Groundwater Application Review Summary Form

Application # G- 18998

TO: Water Rights Section Date 09/08/2020
 FROM: Groundwater Section Aurora C Bouchier
 Reviewer's Name
 SUBJECT: Application G- 18998 Supersedes review of na
 Date of Review(s)

A. GENERAL INFORMATION: Applicant's Name: Regina Kaye Derstine & Trevor Derstine County: Jefferson

Water-Level Measurements in Nearby Wells

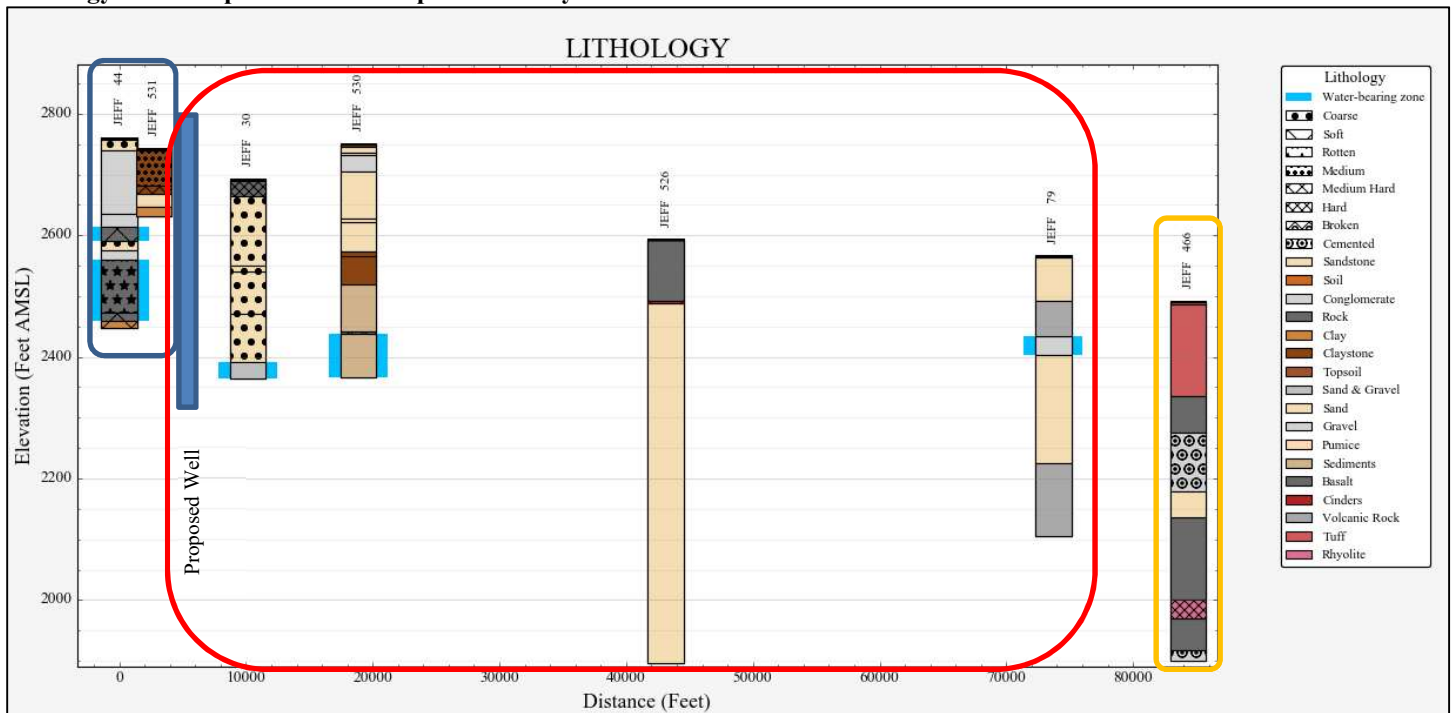
A nearby observation well (JEFF 466, located approximately 6-miles to the north-northeast near the town of Madras) has been monitored periodically since the mid 1980’s. The hydrograph of JEFF 466 appears to show a response to climate cycles of the Northern Oregon Cascades. However, the magnitude (approximately 7-feet) of the response to climate cycles in JEFF 466 is muted and slightly delayed when compared to the magnitude (approximately 24-feet) of response to climate cycles in DESC 3016 (located in Sisters) – which shows a strong correlation with climate cycles. JEFF 466 does not display a declining groundwater trend.

Lithology and Comparative Well Depth of Nearby Wells

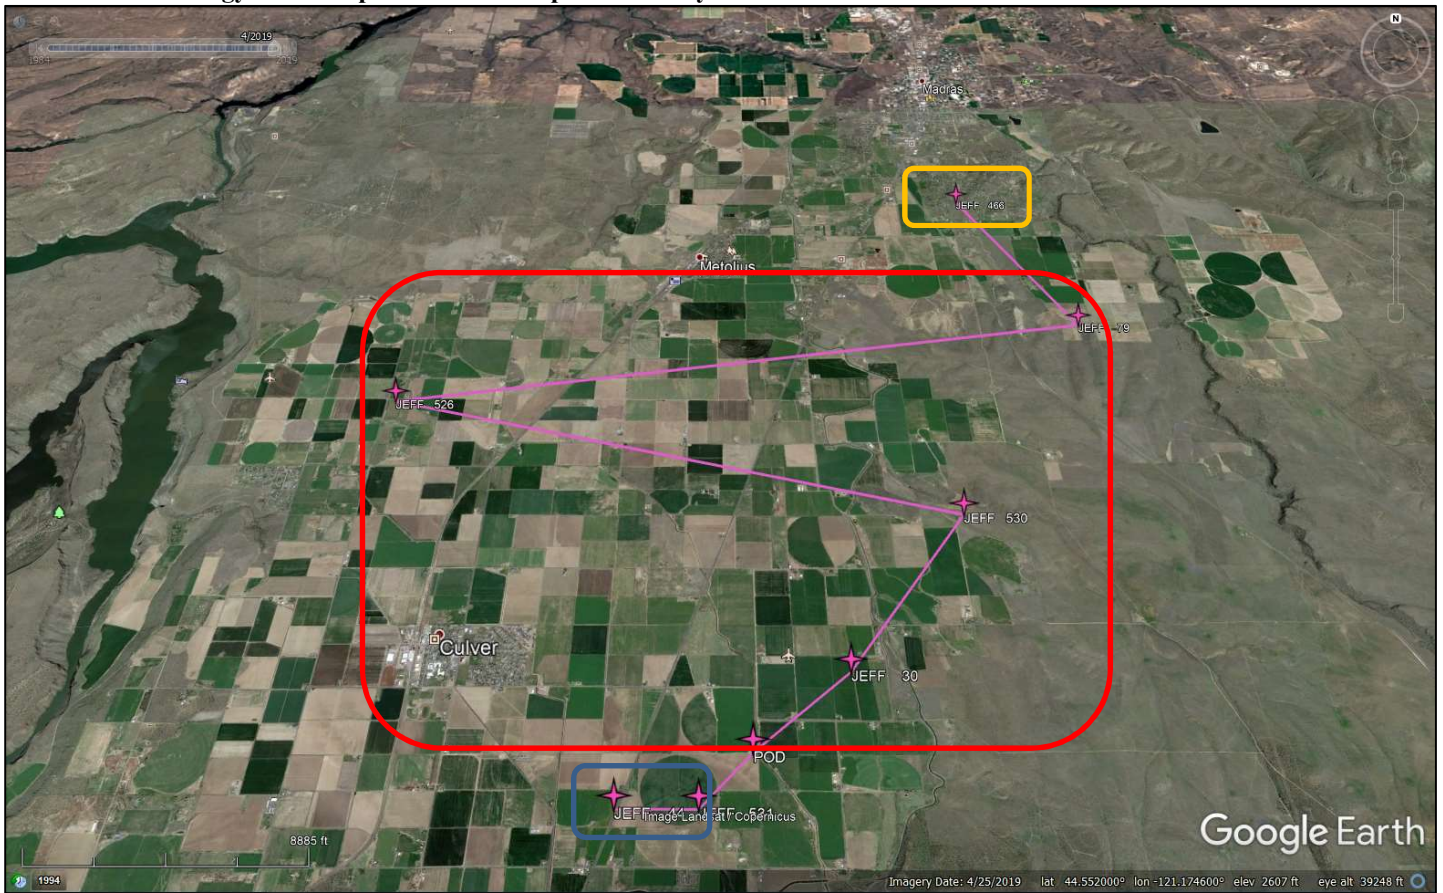
There are 20 water wells in the proposed township and range (T12S/R13E). Of these, the median estimated yield is 15 gpm and the maximum estimated yield is 50 gpm. It is unlikely the applicant will find the requested rate (2168 gpm) at the proposed well depth (490 feet). Three high-yield wells exist at a location approximately 6.5-miles to the west-southwest (in T12S/R12E Section 33, along the Crooked River). At the proposed location, a well would have to be a minimum of approximately 900 to 1200 feet deep to tap into the same water-bearing zone that the wells in T12S/R12E-S33 are producing from – and there is no guarantee that this zone would be water-bearing at the proposed location.
